Re: Application for a Certificate of Appropriateness to Build a New Home at 3701 Council Crest, a Designated City Landmark
Legistar ID No. 79099

To: Landmarks Commission
Legistar File 79099 [3701 Council Crest]
Commission meeting date: August 14, 2023

**Susceptibility of black walnut tree (Lot 2 of the Old Spring Tavern)
to destruction due to proposed construction project**

Illustration on same scale and noting elevation difference from Council Crest to the front door of the OST.

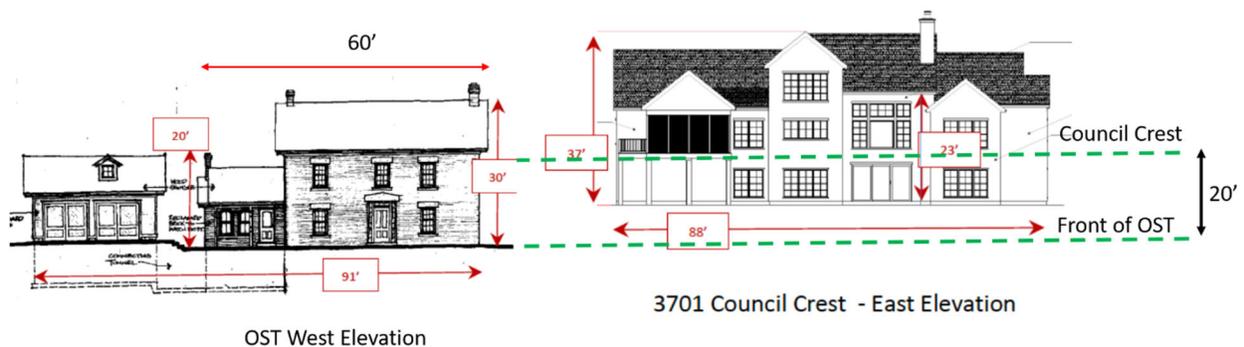
The buildings in the figure in the application under bullet 6 are not exactly at the same scale. I have also added the relative elevation of the two buildings given the supplied application drawings and the known relative elevation differences. It should be noted that the historic building, the OST, is actually ~60' not 91' as illustrated if you remove the green space and garage (not part of the original building site).

As can easily be seen in the figure, the new construction neither fits nor complements historic landmark. It overshadows and dominates the property, as currently proposed. It dominates in height and it dominates in volume and diminishes the historic site and its value in a dramatic fashion. The future use, construction on and modification of the intervening property (within the 78') is also not well noted and would additionally 'crowd' the remaining space associated with the historic landmark. This proposed construction does not meet the **Interior's Standards for Rehabilitation for Granting a Certificate of Appropriateness** which require 'minimal change to the defining characteristics of the building and its site and environment'.

In evaluating the proposed work, it is important to use accurate and relevant comparisons. In reading the application, there are conclusions mixed with data. For example, bullet 6: "**Our Planned Home is Consistent in Scale with the Tavern Residence**". The tavern residence, designated as a landmark, is 60' not 91'. Their bolded text is an interpretation not a fact. Bullet 4 states, '**Preserving Existing Site Elements**', and references retaining the black cast iron fence. While this is laudable, it is not part of the historic site as implied. Bullet 7 states; '**Our Planned Home is Consistent with Adjacent Development**'. This is cherry picking comparison sites, principally on Nakoma road, which does not include Council Crest and the immediate neighboring buildings which are most relevant.

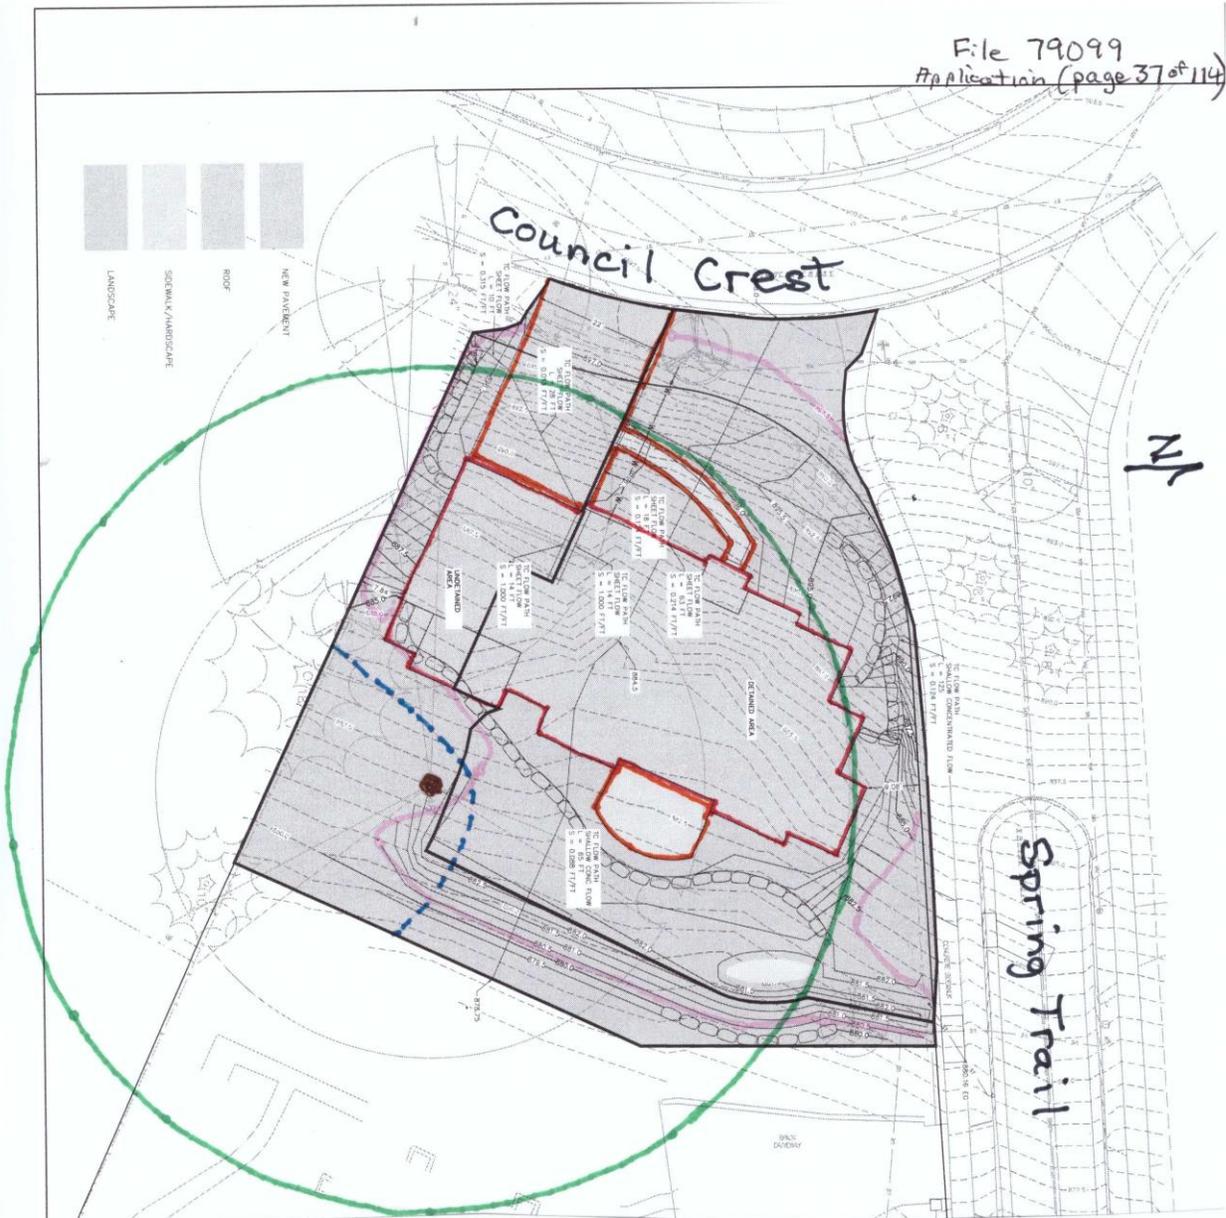
Multiplying 17 times a DBH of 52” for this tree yields a circular TPZ with a radius of 884” or approximately 74 feet from the tree.³ **This is the radius shown on the attached diagram entitled “circular Tree Protection Zone.”** A 74’ radius is approximately the same distance as between the eastern wall of the proposed residence and the western wall of the Old Spring Tavern. The TPZ for the heritage black walnut tree on Lot 2 includes all but the furthest reaches of the lot, approximately 75% of the lot or about 8,100 of the lot’s 10,832 square feet. It is a common practice to fence-off the TPZ prior to any construction activity so that it is protected from excavation, material storage, and heavy vehicles.

The **second diagram** attached to this memo contrasts the Tree Protection Zone that should be applied to construction on Lot 2 of the Old Spring Tavern site compared to the those areas of Lot 2 that would be: 1) excavated to contain the proposed structure as designed; 2) additional areas in Lot 2 that would be excavated for constructing the driveway, the brick paver walk, and the brick paver patio; 3) additional areas in Lot 2 that would be excavated or filled in order to create the topography behind the hydrology study that is included in the application; and 4) the tiny corner of Lot 2 shown on the landscape plan (that accompanied the April application) designated as the only portion of Lot 2 where “heavy machinery” will be kept off of the “walnut tree root zone.”⁴

My estimate is that a full 40% of the TPZ would be damaged by the proposed project. I believe this damage would translate to “certain destruction” of the black walnut tree that is central to (and provides context for) the site of the Old Spring Tavern.
